AMENDMENT OF SOLICITATION/MODIFICATION OF CONTRACT			1. CONTRACT ID CODE	PAGE OF PAGES	
			J	1	2
2. AMENDMENT/MODIFICATION NO. 0005	3. EFFECTIVE DATE 02-Jul-2003	4. REQUISITION/PURCHASE REQ. NO. W26GLG-3107-8937		5. PROJECT NO.(If applicable)

14. DESCRIPTION OF AMENDMENT/MODIFICATION (Organized by UCF section headings, including solicitation/contract subject matter where feasible.) AMENDMENT NO. 0005 to DACA65-03-R-0023, Maneuver and Training Equipment Site (MATES), Fort Pickett, VA.					
Except as provided herein, all terms and conditions of the document referenced in Item 9A or 10A, as heretofore changed, remains unchanged and in full force and effect.					
15A. NAME AND TITLE OF SIGNER (Type or print)			16A. NAME AND TITLE OF CONTRACTING OFFICER (Type or print)		
			TEL: _____ EMAIL: _____		
15B. CONTRACTOR/OFFEROR  (Signature of person authorized to sign)	15C. DATE SIGNED	16B. UNITED STATES OF AMERICA  BY _____ (Signature of Contracting Officer)		16C. DATE SIGNED 02-Jul-2003

`PREPROPOSAL CONFERENCE MINUTES  
JUNE 25, 2003  
DACA65-03-R-0023  
MANUEVUER AND TRAINING EQUIPMENT SITE (MATES)  
FORT PICKETT, VA

PREPROPOSAL CONFERENCE QUESTIONS AND ANSWERS  
DACA65-03-R-0023  
MAN

Sheet reference number: **03**

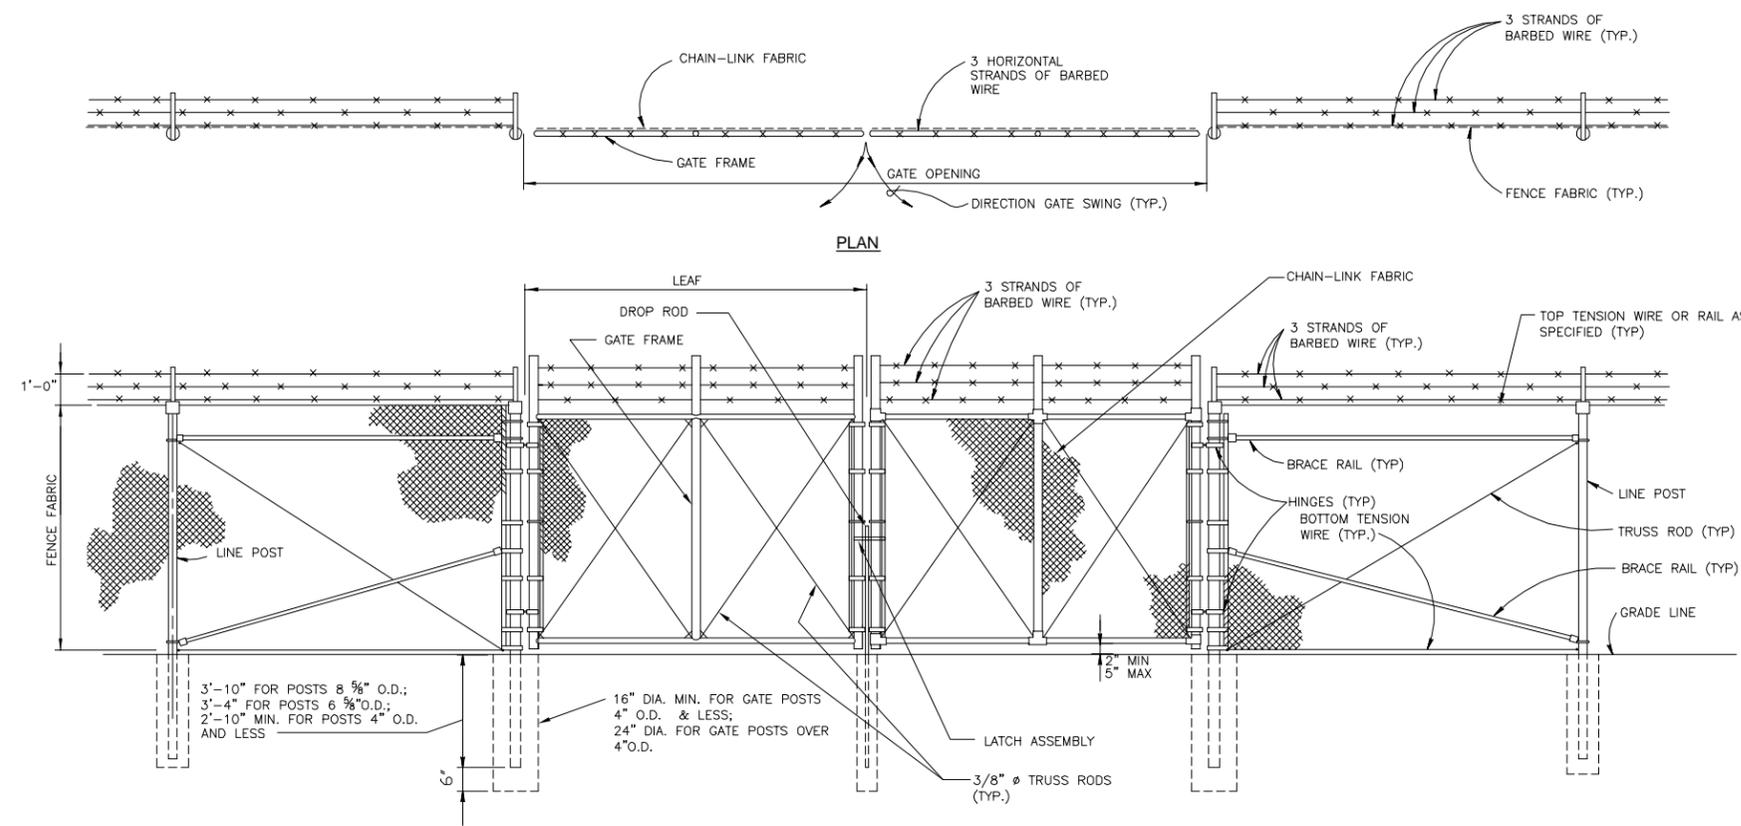
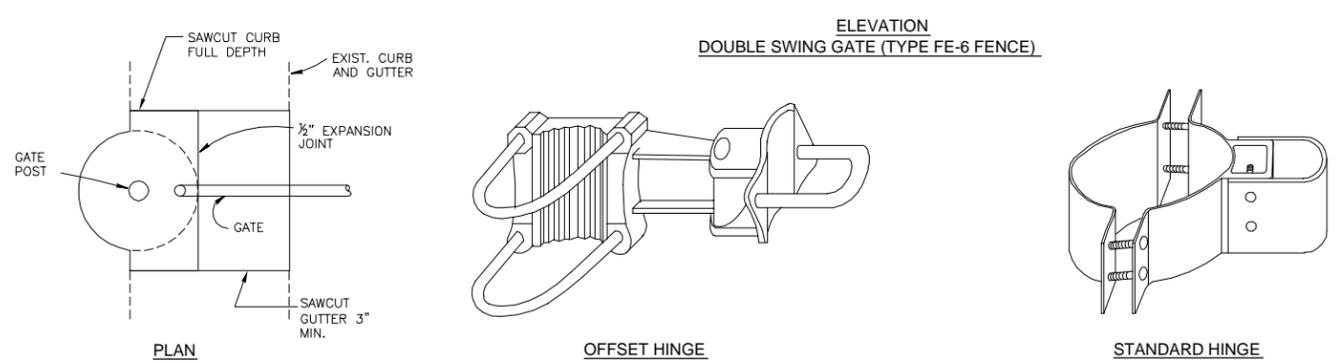
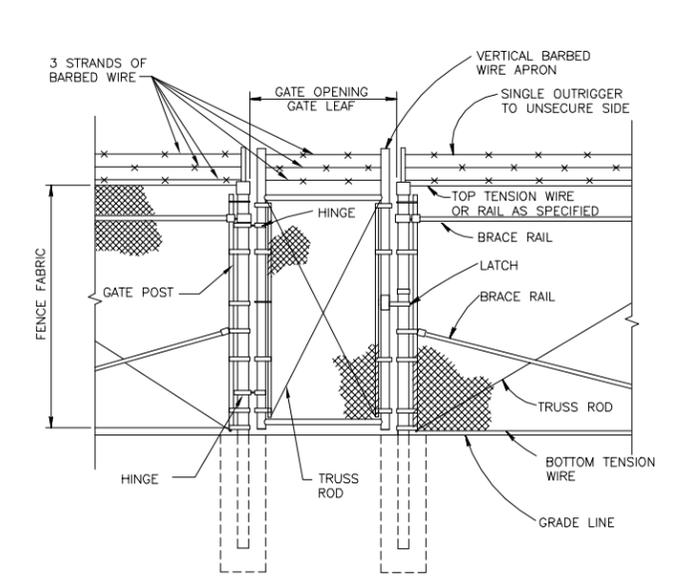
4. On Dwg G-001, Fence to comply with AR-190-51 std. Where can I get a copy of this?

The drawing will be revised by Amendment to coordinate with the specific requirements in the Statement of Work. Attached to this Amendment is STD 872-90-03 which has fencing details as referenced in the Statement of Work.
